Commonwealth Edison Company  
Byron/Braidwood Units 1 and 2  
Relaxation of MSSV Setpoint Tolerance to +/-3% - Revised SECL

Enclosed please find Revision 1 to safety evaluation SECL 90-469, previously transmitted via Reference 1. The revised safety evaluation clarifies the section of the ASME code associated with the main steam safety valves.

WESTINGHOUSE NUCLEAR SAFETY  
SAFETY EVALUATION CHECK LIST

APPENDIX B  
UFSAR MARKUPS

**FIGURE 15.2-4**

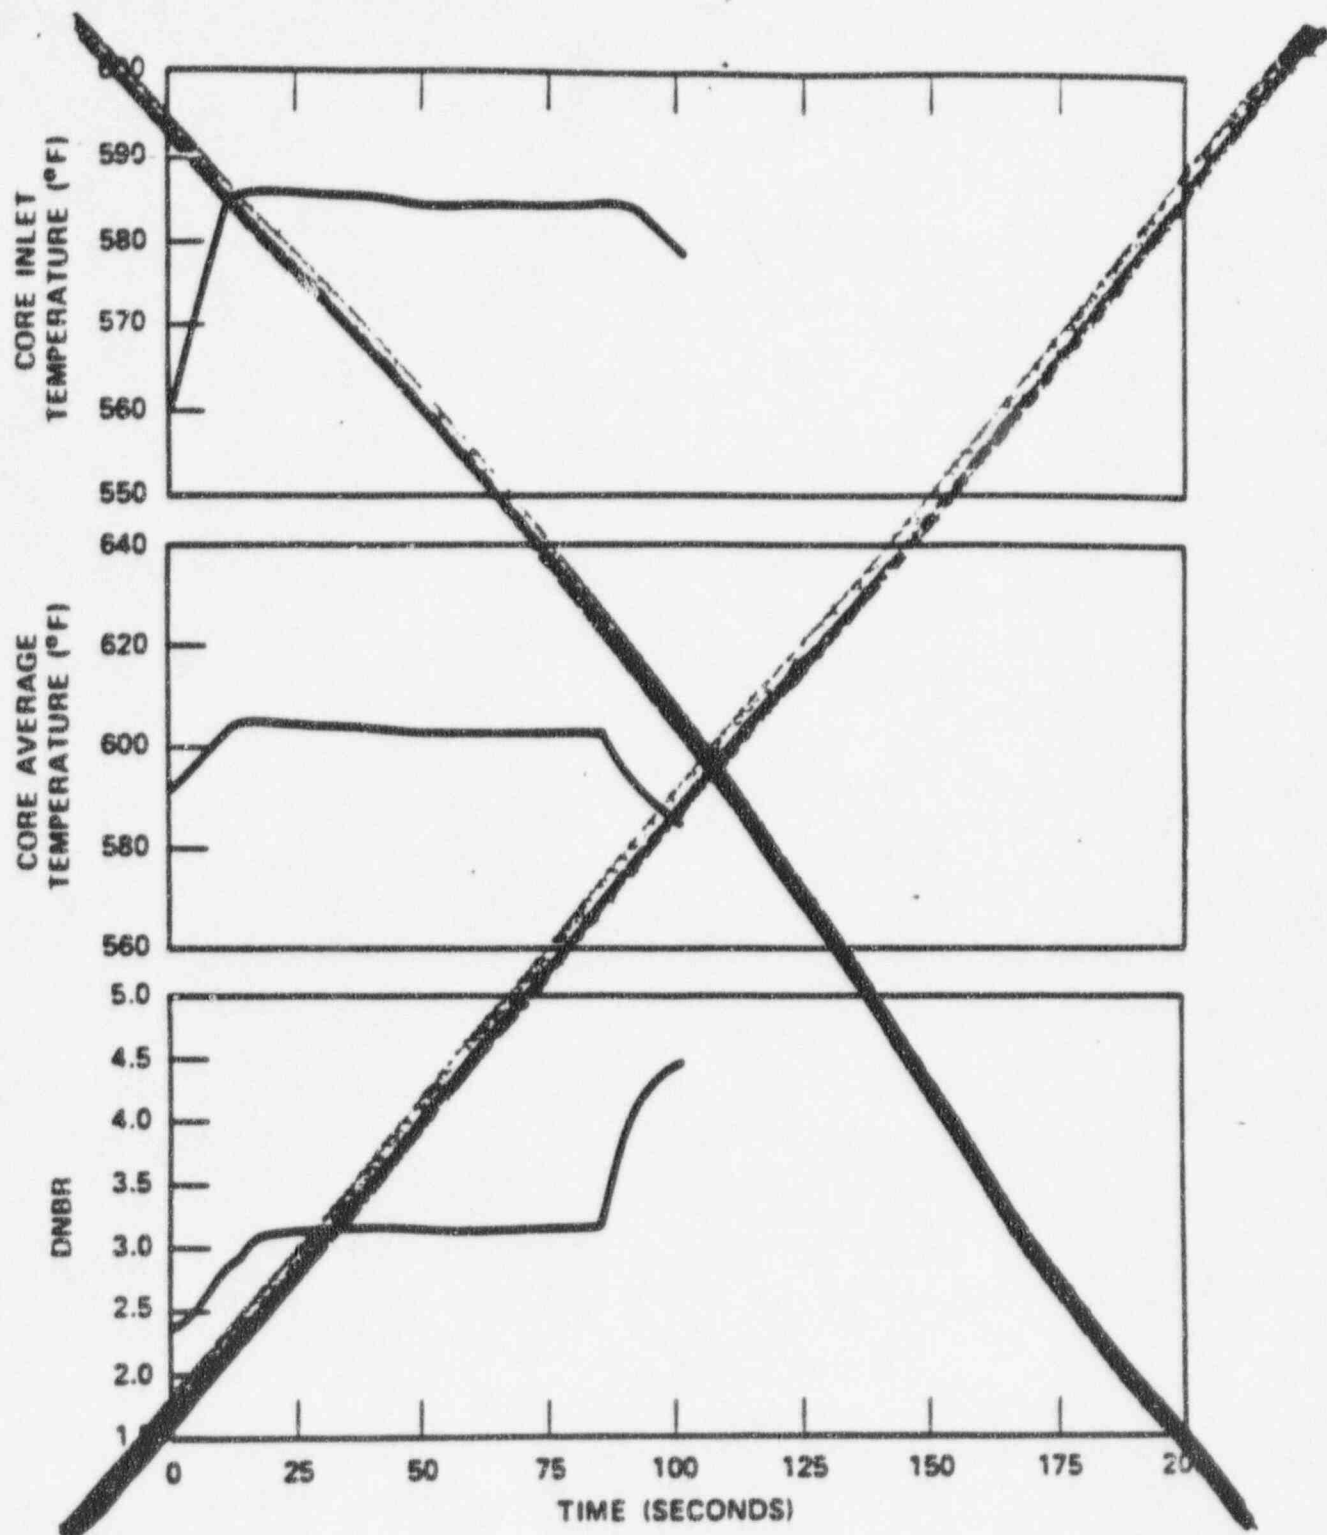
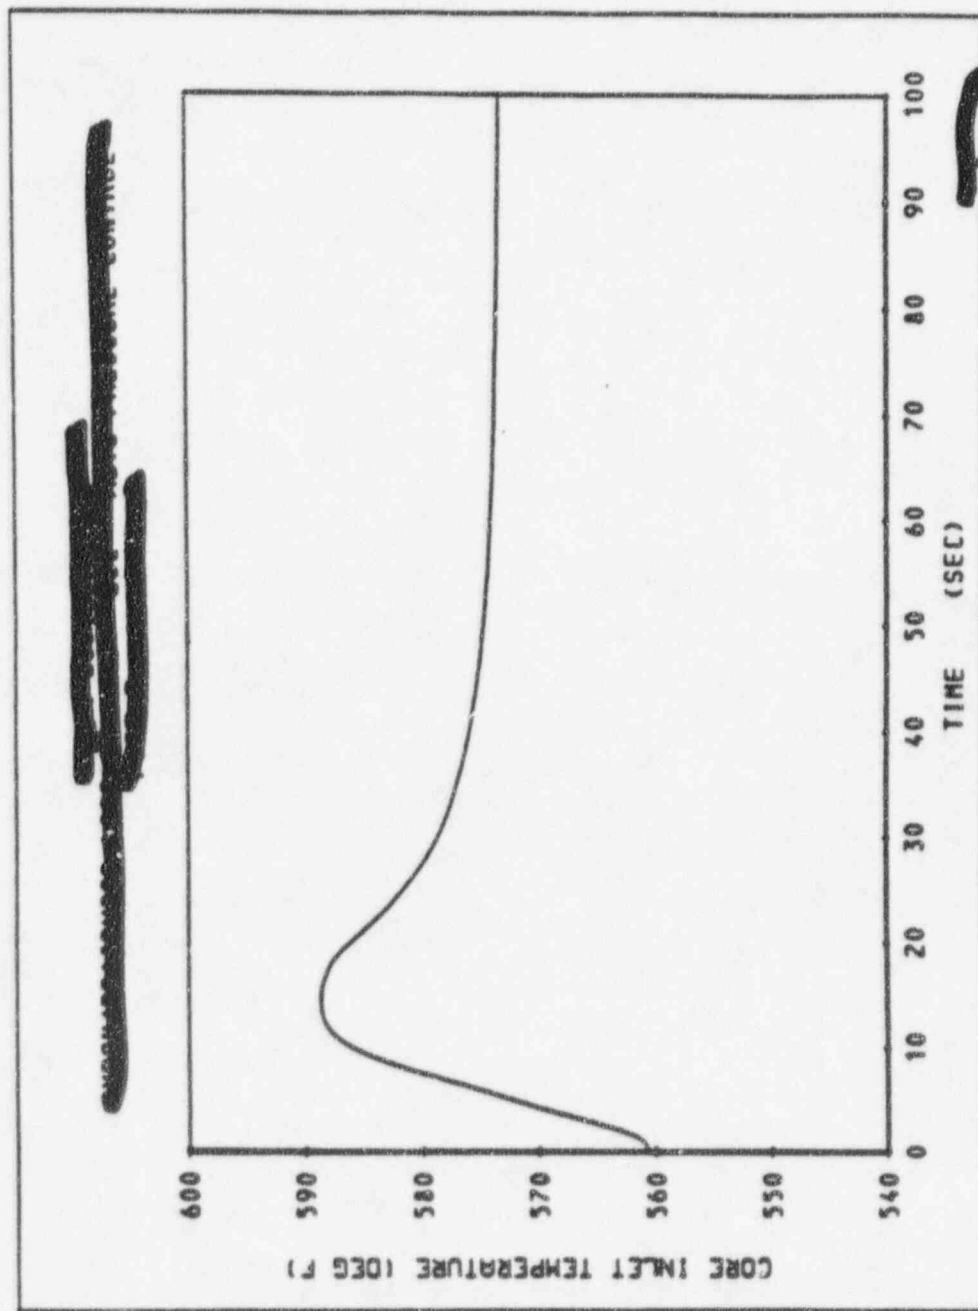
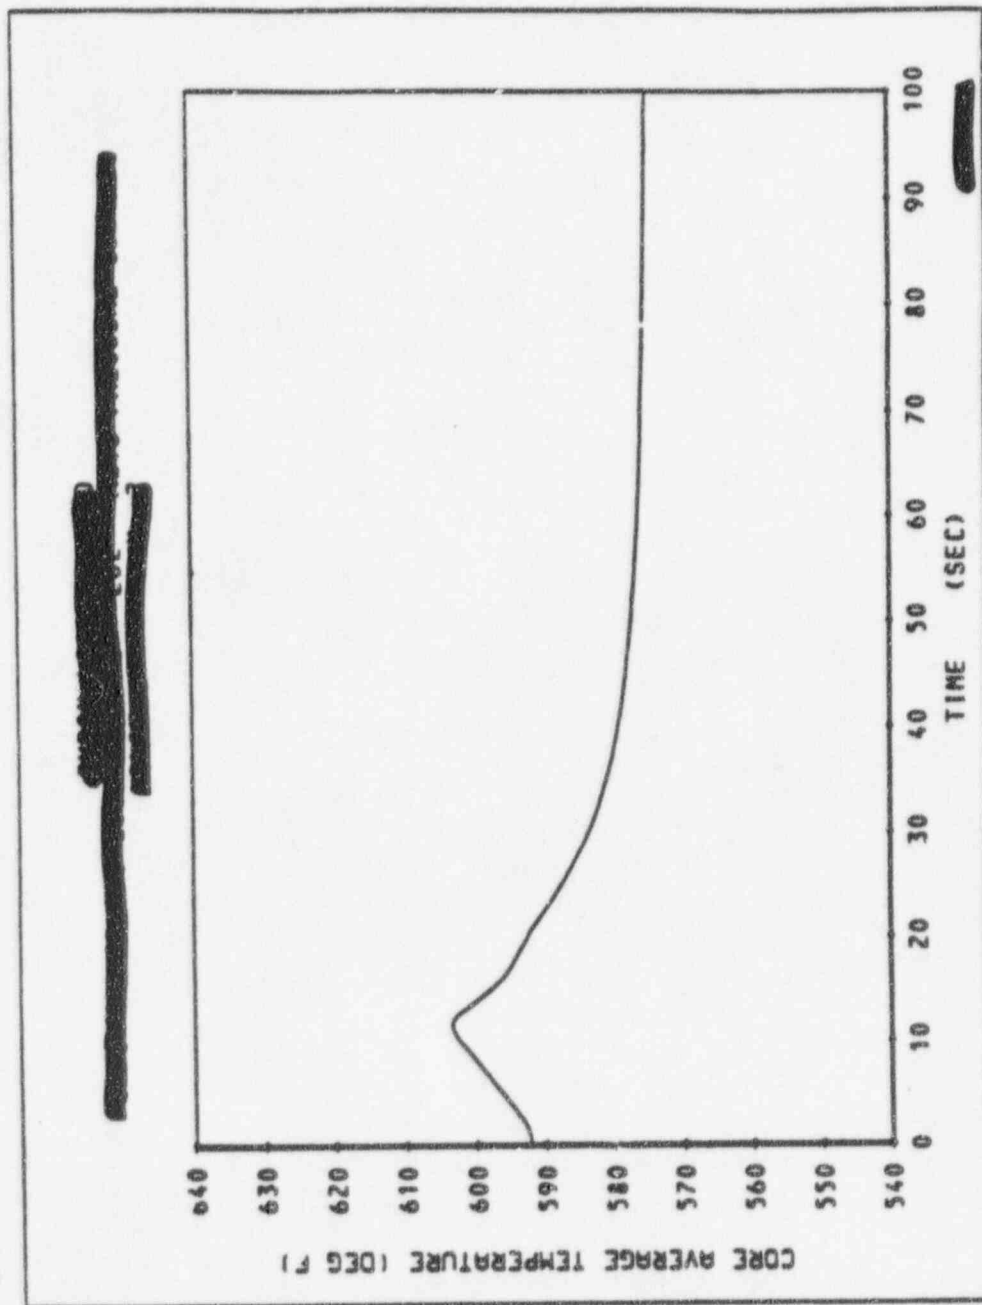
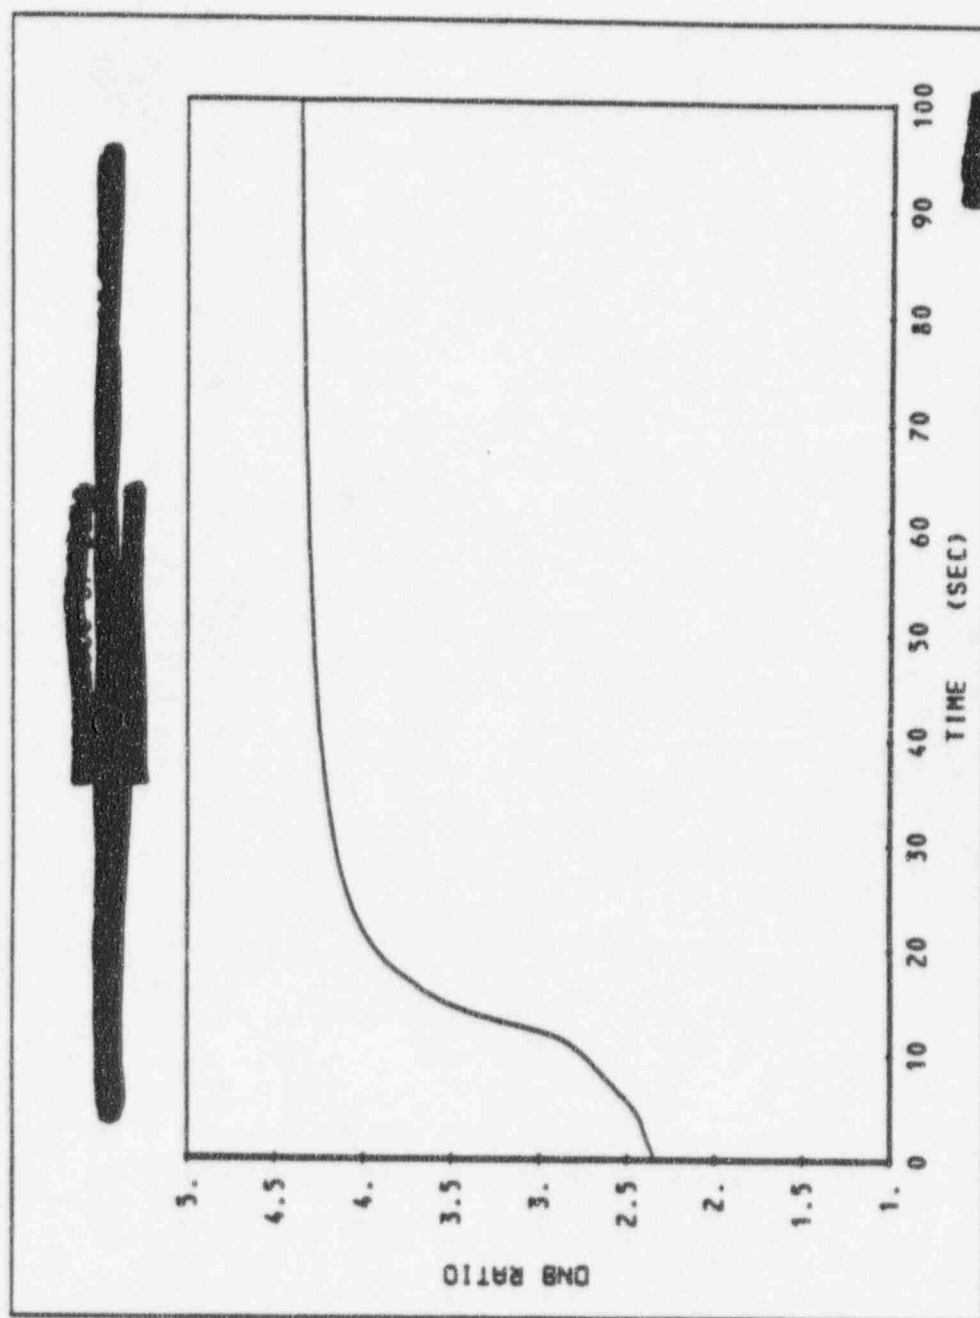
Figures 15.2-3 and 15.2-4 show the response for the total loss of steam load with a large negative moderator temperature coefficient. All other plant parameters are the same as the above. The DNBR increases throughout the transient and never drops below its initial value. Pressurizer relief valves and steam generator

REPLACE WITH  
the following  
Figures
